NATIONAL TRANSPORTATION SAFETY BOARD

TRANSPORTATION SAFETY RECOMMENDATIONS

ADOPTED DURING THE MONTH
OF DECEMBER, 1998

1. Report No. NTSB/REC-98/12	2. Government Accession No. PB98-916612	3. Recipient's Catalog No.	
4. Title and Subtitle Transportation Safety Recommendations - Adopted during the month of September, 1998.		5. Report Date

Figure 1. Cross section of CF6-50 engine and expanded view of LPT module

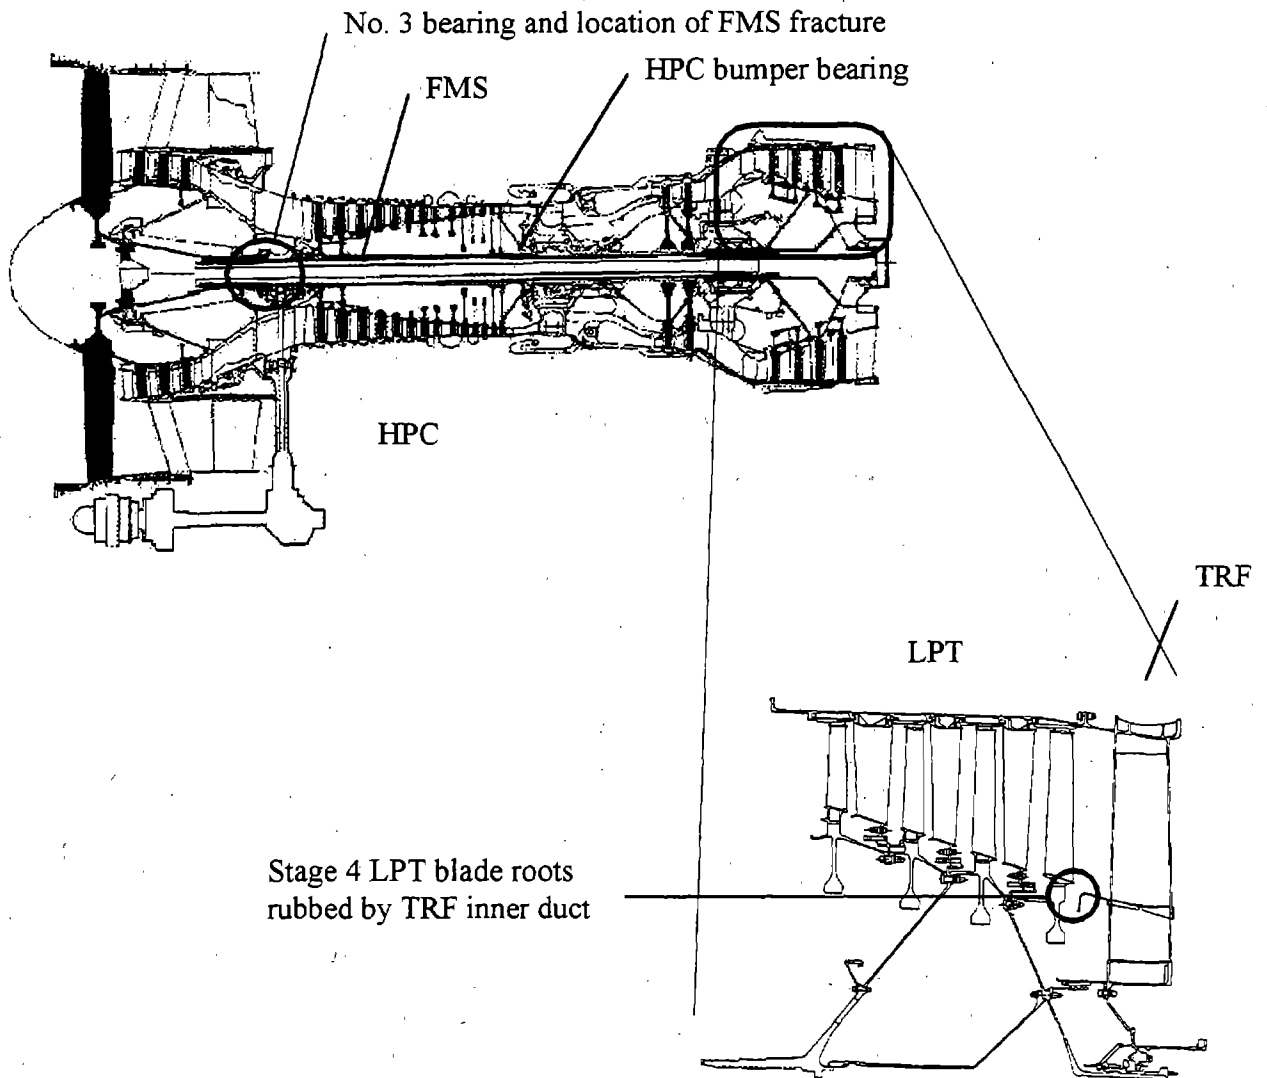
The examination of the No. 2 engine revealed that most of the LPT module was missing (see figure 1). The airplane had punctures to its left wing leading edge slats and to a landing gear door. In addition, the No. 1 engine had hard body impact damage⁴ to 18 of the 38 fan blades, and the fan cowl had impact damage from the debris ejected from the No. 2 engine.

The Safety Board is concerned about the potential for other FMS fractures from rubs sufficient to overheat the material and reduce its tensile and fatigue properties but not sufficient to cause damage warranting an inspection of the shafts. However, the Safety Board notes that as a result of the PIA investigation, GE issued Alert Service Bulletin CF6-50 72-A1120 on April 4, 1997, which identifies other CF6-50 FMSs that had been rubbed and provides a one-time eddy current inspection procedure to identify and remove from service any FMSs that were overheated.

The disassembly of the PIA engine showed that the center section of the FMS had become wedged into the high pressure compressor (HPC) bumper bearings. The design of the CF6-50 engine's FMS is such that the OD of the forward half of the shaft is greater than the inner diameter of the bumper bearing on the inside of the HPC rear hub. On the PIA engine, when the FMS fractured at its forward end, the rear section moved aft, and the larger diameter section of the shaft became wedged into the bumper bearing, limiting the rearward movement of the LPT

rotor. With the FMS wedged into the bumper bearing, the LPT rotor was then driven by the high pressure rotor, which has a rotational speed more than twice the rpm limit of the low pressure rotor. Additionally, two stage 4 LPT blade roots recovered from the core cowl had circumferential grooves on their rear faces. The grooves corresponded to the forward edge of the turbine rear frame (TRF) inner duct, indicating that additional structure had limited the rearward movement of the LPT rotor and meshing¹¹ action, thus permitting the rotor to overspeed. Several stage 1 LPT blades recovered from the wing slat area were rubbed on the rear faces of their roots and had the rear portions of the blade root serrations sheared consistent with the radial outward movement of the blades, suggesting that those blades were pushed out of the disk from the rear and separated under high-centrifugal loads.

Require General Electric Aircraft Engines to modify the CF6-50 engine to eliminate the impediments to the aft translation of the low pressure turbine rotor that limits the amount of meshing that occurs in the event of a fan midshaft fracture. (A-98-125)

Figure 2. Cross section of CF6-80C2 engine and expanded view of LPT module

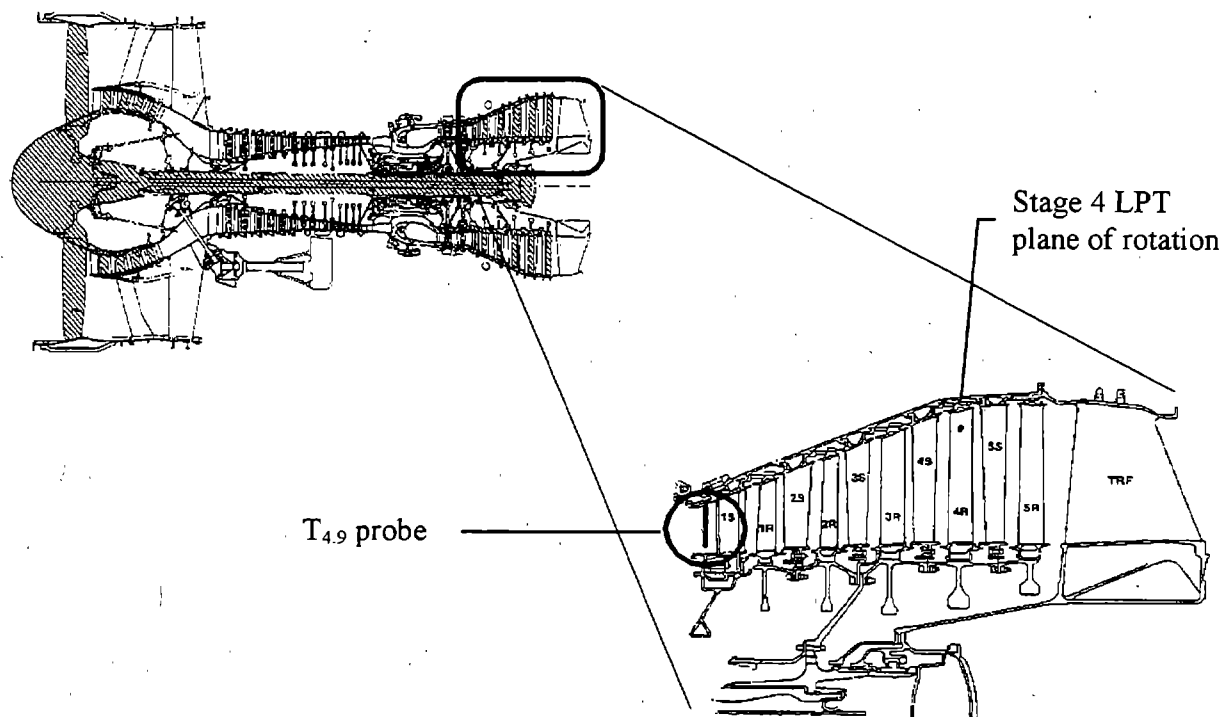
Examination of the No. 1 engine revealed that the core cowl had a 15-inch long (circumferential) by 6-inch wide (axial) hole in the plane of the stage 4 LPT rotor. There were numerous dents and impact marks on the underside of the left wing's inboard aileron and the outboard side of the inboard flap track fairing, both of which are directly aft of the No. 1 engine's exhaust.¹⁴

The engine was disassembled and examined under the direction of the Safety Board at Motoren-und Turbinen-Union (MTU), Hannover, Germany.¹⁵ The disassembly revealed that the tip of one interturbine temperature ($T_{4.9}$)¹⁶ probe had broken off and impacted one stage 1 LPT blade, causing a fatigue fracture of the airfoil near the blade tip shroud (see figure 2). All of the stage 2, 3, 4, and 5 LPT blades were found in their respective disks; however, all were fractured transversely across the airfoils at various lengths above the blade root platforms. The disassembly also revealed that the LPT case had a 17-inch by 2-inch wide hole in the stage 4 LPT plane of rotation. The damage to the LPT rotor was progressively worse along the gaspath, suggesting that the stage 1 LPT blade tip separated first, that all of the blades in the following stages were then fractured, and that the mass of material became larger as it progressed through the rotor, subsequently resulting in a case rupture in the stage 4 area.

The Safety Board is aware of a similar event that occurred on September 5, 1997, when a Federal Express (FedEx) McDonnell Douglas MD-11 airplane, equipped with GE CF6-80C2 engines, had an uncontained LPT failure in the plane of the stage 4 LPT rotor. The disassembly of the FedEx engine showed that a stage 1 LPT airseal segment had broken loose from the LPT case and passed through the gaspath causing the breakage of the downstream turbine blades. As in the American Airlines LPT, the damage in the FedEx LPT rotor was more extensive downstream along the gaspath. The evidence shows that both the American Airlines and FedEx LPT cases withstood the initial containment challenge of the separation of an LPT blade; however, neither case could withstand the loads imparted by the resultant mass of broken LPT airfoils. This suggests that the design containment capability of the LPT case is inadequate.

turbine containment are further addressed in 14 CFR 33.75, which notes in part that "any probable single or multiple failure...will not cause an engine to...burst (release hazardous fragments through the engine case)." Because the uncontained LPT failures in the CF6-50 and -80C2 engines were attributed to a number of different causes, the LPT containment capability of these engines must be improved to comply with 14 CFR 33.19 and 33.75.

Require General Electric Aircraft Engines to improve the ability of the CF6-50 and the CF6-80 series engines to prevent fractured low pressure turbine blades from being liberated through the engine cowling. (A-98-126)
